Subject: Resolution Approving a Final Settlement Agreement with the Performing Arts Center Trust and PAC Builders for Repairs to the Rain Water Leader System at the Adrienne Arsht Center for the Performing Arts of Miami-Dade County

**FINAL SETTLEMENT AGREEMENT REGARDING PERFORMANCE OF RAIN
WATER LEADER SYSTEM WORK**

Re: PAC Arbitration regarding Rain Water Leaders
Page FIVE
May 9, 2014

ARBITRATION ASSESSMENT

* INDICATE LOCATION OF PROPOSED JR'S

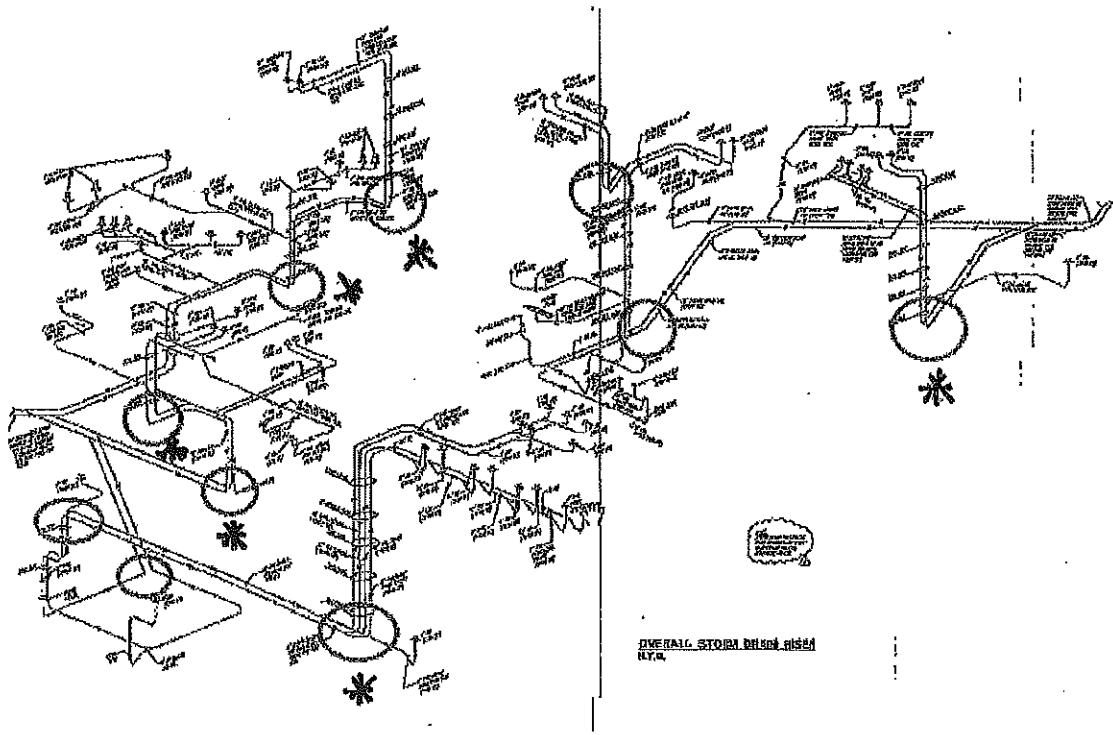
- 1) (a) Joint restraints are not required at every joint at every change of pipe direction.
- (b) Joint restraints, in our professional opinion, are required at specific locations specified here in.
- 2) Refer to marked-up copy of Appendix 'E', provided by Dade County, for our recommended locations of joint restraints.
- 3) Based on a review of the RWL system at the Performing Arts Center of Greater Miami, the design drawings and specifications, applicable codes and industry standards-of-care, the implementation of my developed attached scope of work (joint restraints only) was not required by PAC Builders under its Amended Agreement, including Change Order 73, with the County.
